Camden Residents' Action Group

Re: Development Application (DA) 257/1/2018

Construction of a BP Service Station to operate 24 hours, 7 days per week, including convenience store with toilets, 4 pump bowsers with awning above, outdoor lighting, service yard, bin storage, new site access, installation of underground fuel storage tanks, retaining walls, signage, landscaping, removal of trees, car parking, drainage and associated site works

Source:
Intersect Traffic
(February 2018)
Traffic and Parking
Assessment
Photograph 3 –
Argyle Street near the
site.

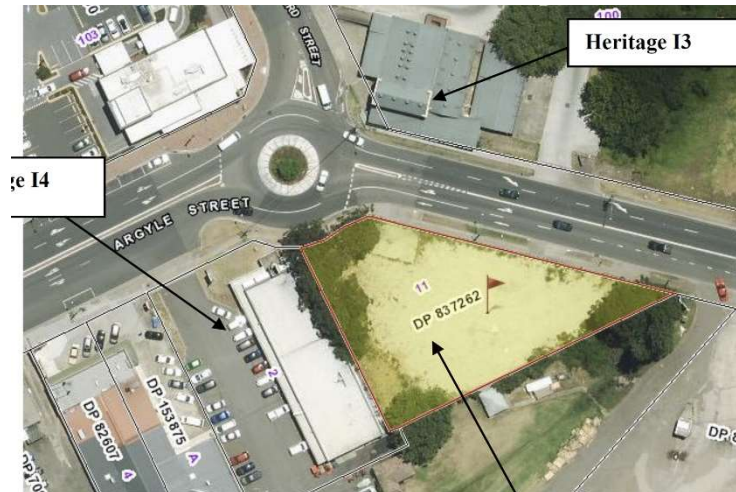
Proposed access to the recently approved Milk Depot development opposite the subject site, for safety reasons, is left in only, requiring a central 900 mm wide raised concrete median strip on Argyle Street to prohibit vehicles travelling west turning right into it.

Therefore, a right turn from Argyle Street for vehicles travelling east into the proposed service station presumably will not be possible. Even so, as the above picture from the study (p.7) shows, this manoeuvre would be difficult across two lanes of traffic, one of which cars are quickly moving into, perhaps to enter the service station as the second lane becomes available, and across a public footpath.

However, the traffic study (4.0, p.6) states *This has little impact on the development at 11 Argyle Street as motorists would be able to utilise the Edward Street (sic)*. It is unclear what this means.

The traffic study does not address how a right turn is to be accommodated into the proposed service station or the effect that this foreseeable difficulty will have on traffic manoeuvres of frustrated drivers.
